# CROSSROADS NORTH PRELIMINARY PLAN

LOCATED IN THE EAST 1/2 OF SECTION 8, T14S, R65W, OF THE 6th P.M., EL PASO COUNTY, COLORADO

# Prelim Plan V\_1 redlines.pdf Markup Summary 12-18-2020

# CROSSROADS NORTH PRELIMINARY PLAN / LANDSCAPE STANDARDS

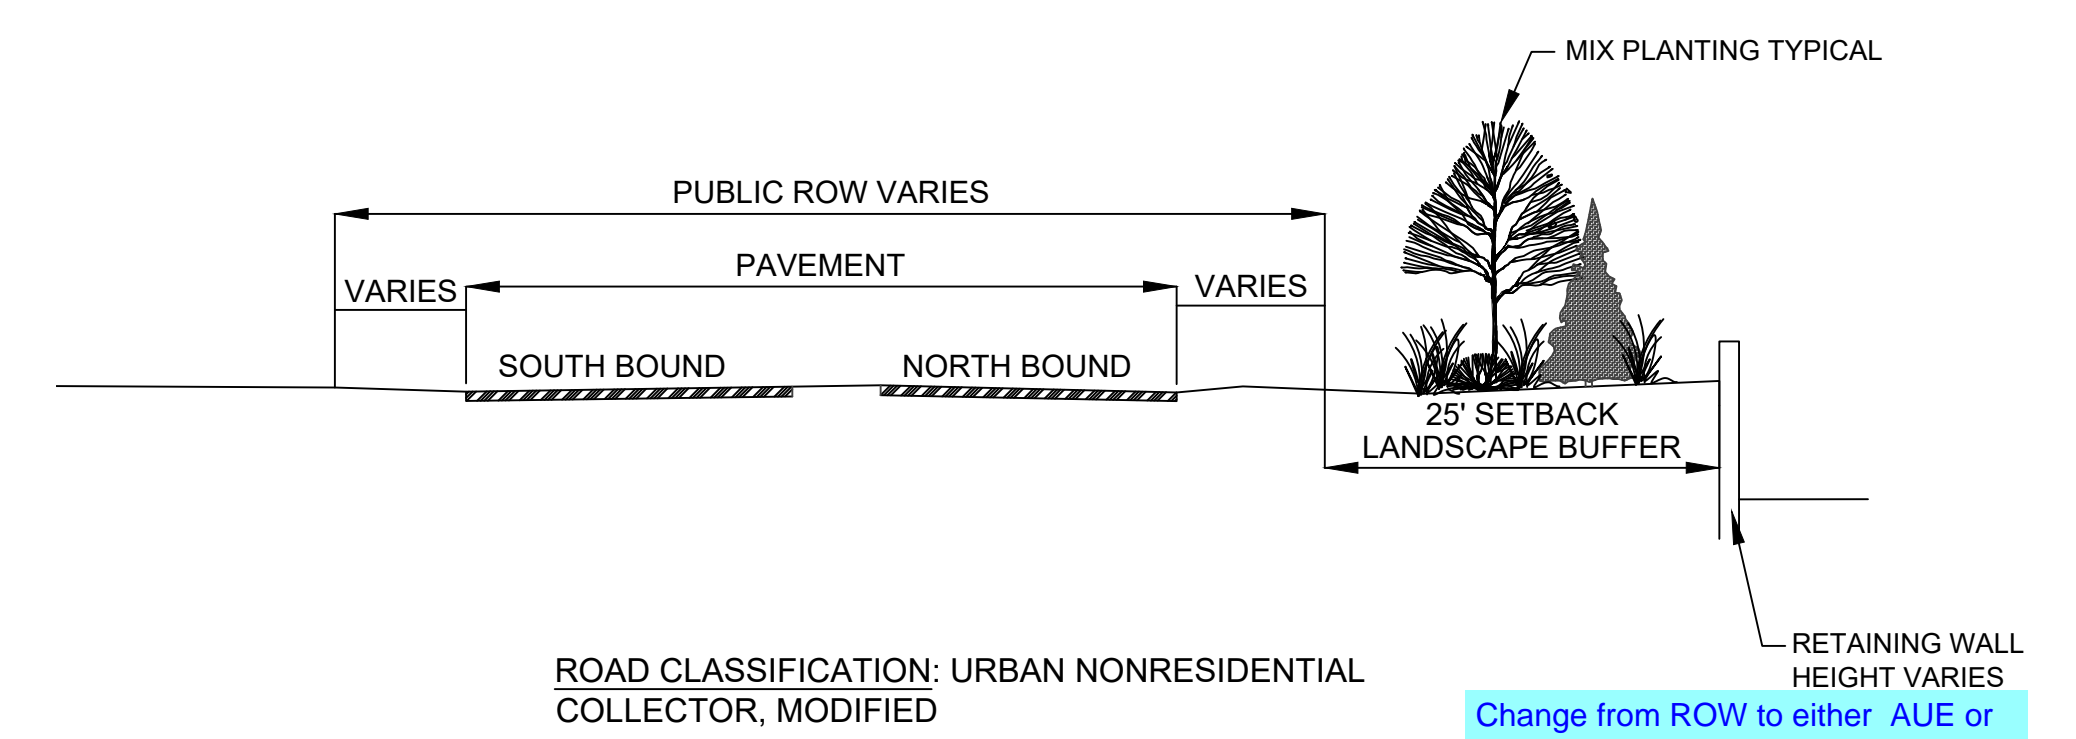
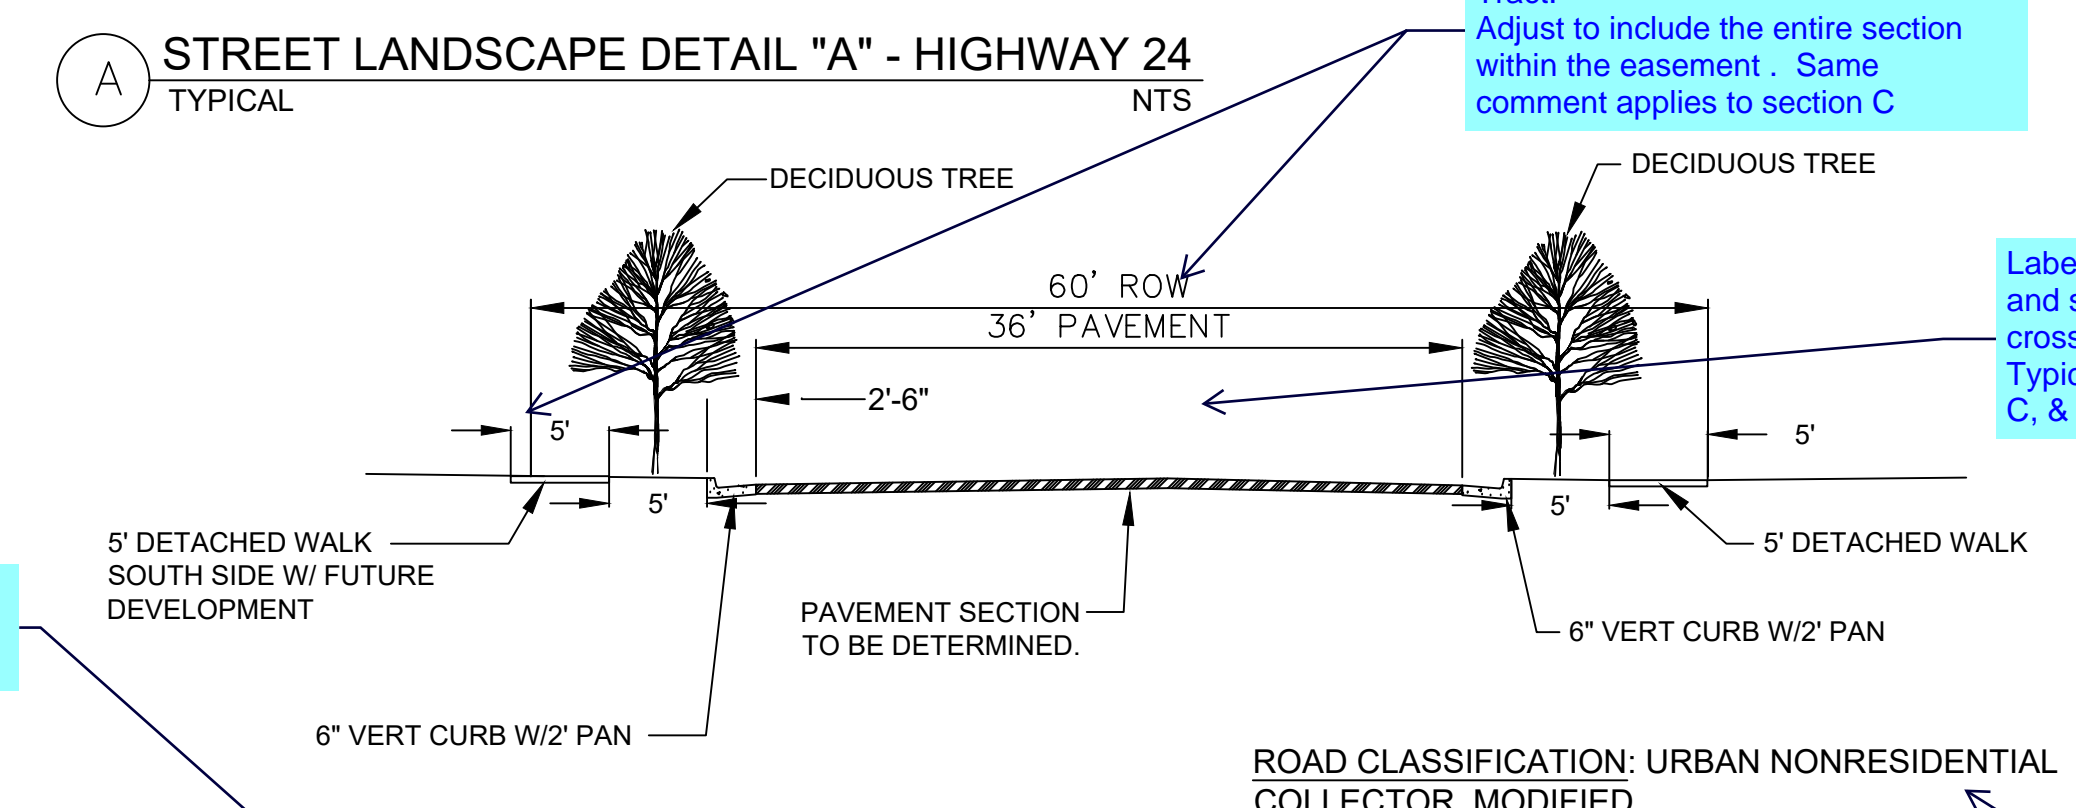
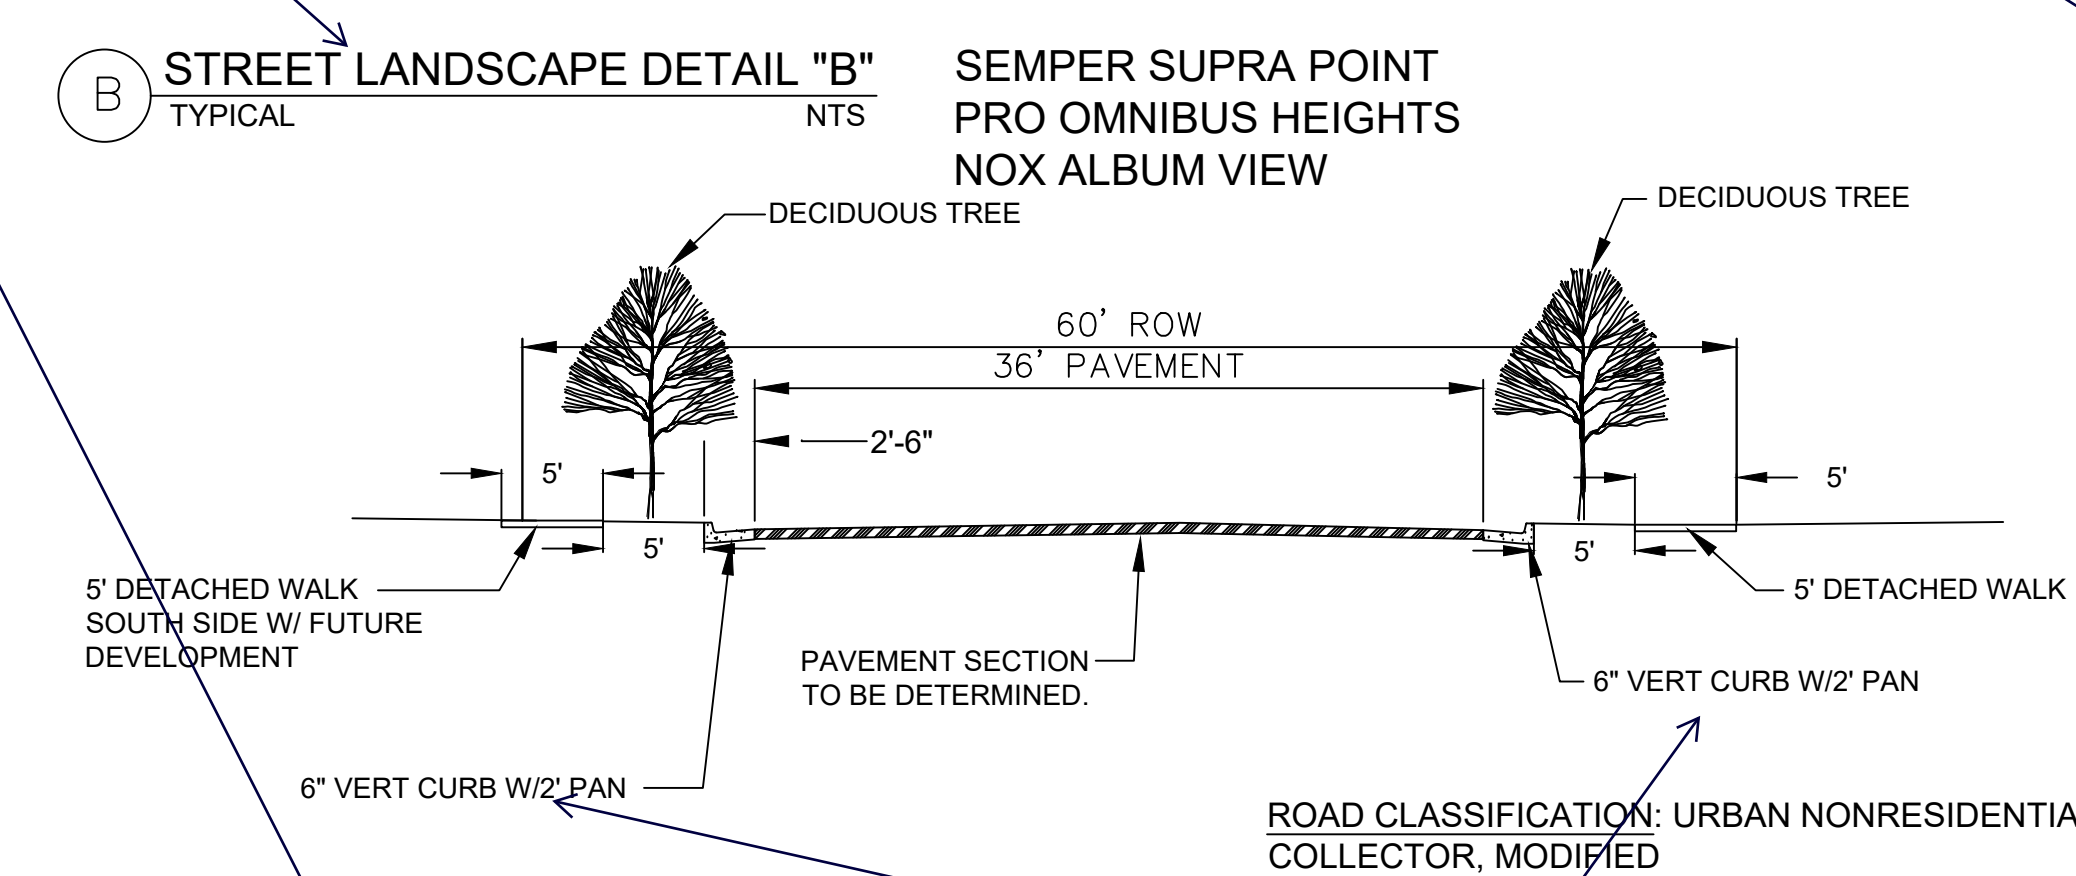
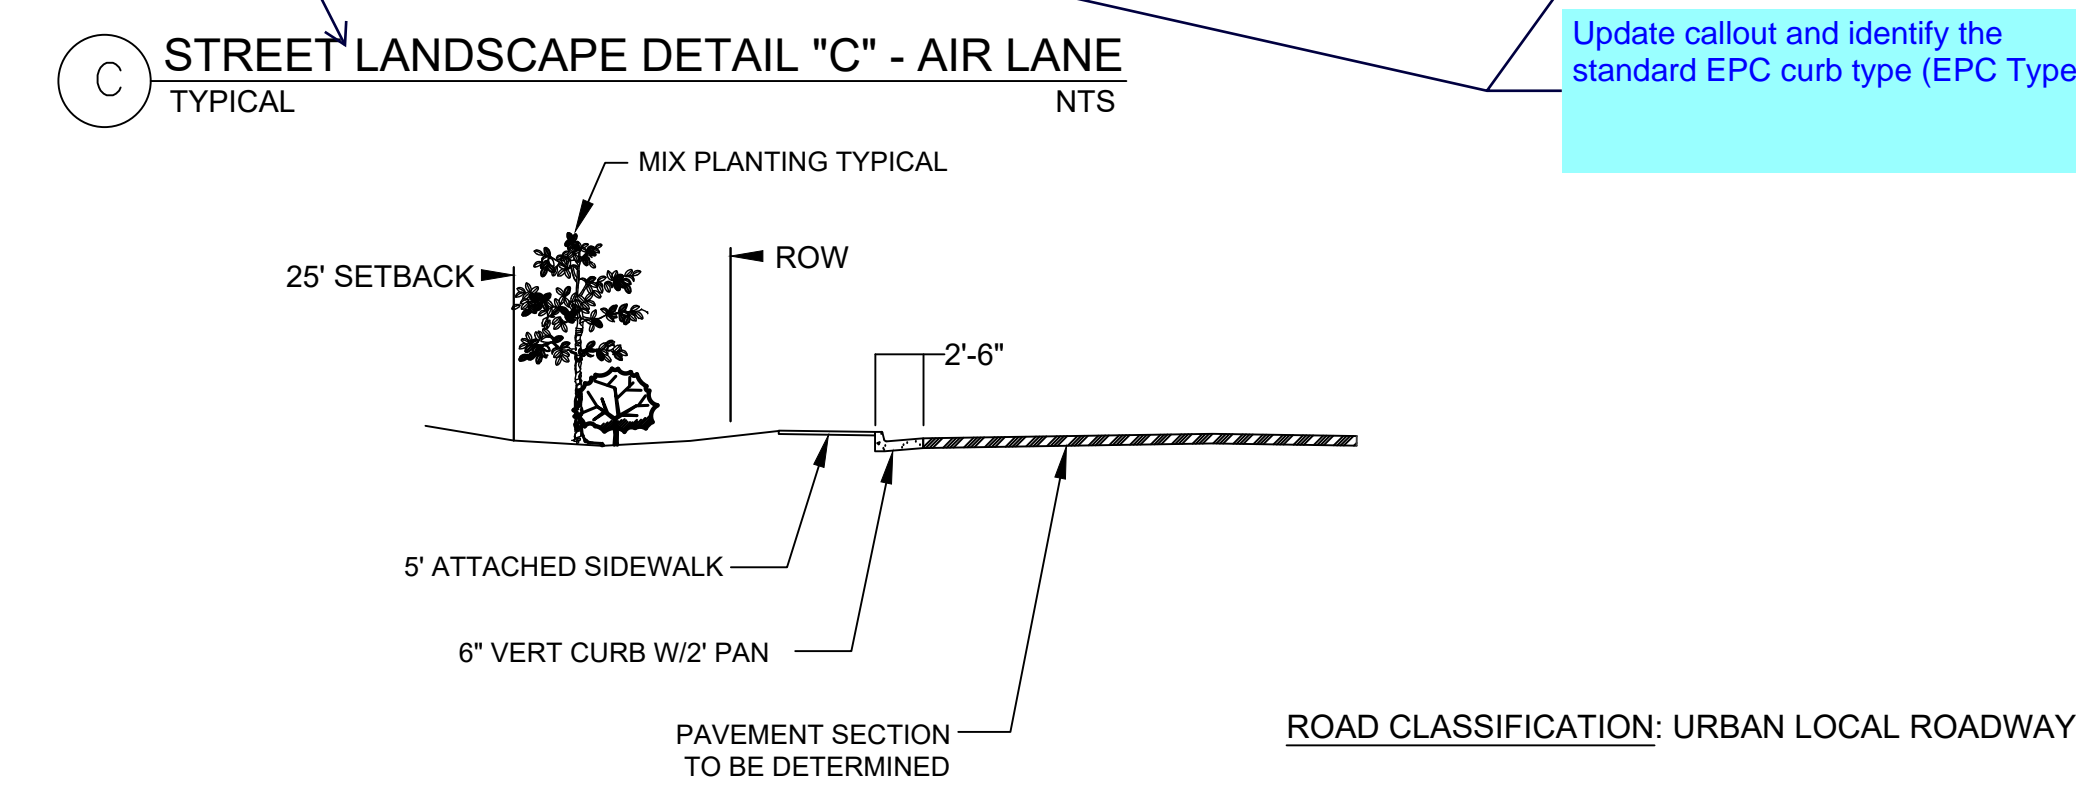
where is the exhibit showing the street trees? please provide and verify line of sight/sight triangles are shown...if Developer is installing with development...if you want to enforce standards shown in details

Change from ROW to either AUE or Tract. Adjust to include the entire section within the easement. Same comment applies to section C

Label lane widths and street/sidewalk cross slopes. Typical for sections B, C, & D

Update Sections B, & C by inserting the word "and" between street landscape.

This requires deviation request from the standard urban non-residential collector cross section. Same comment applies to Section C

Update callout and identify the standard EPC curb type (EPC Type A)
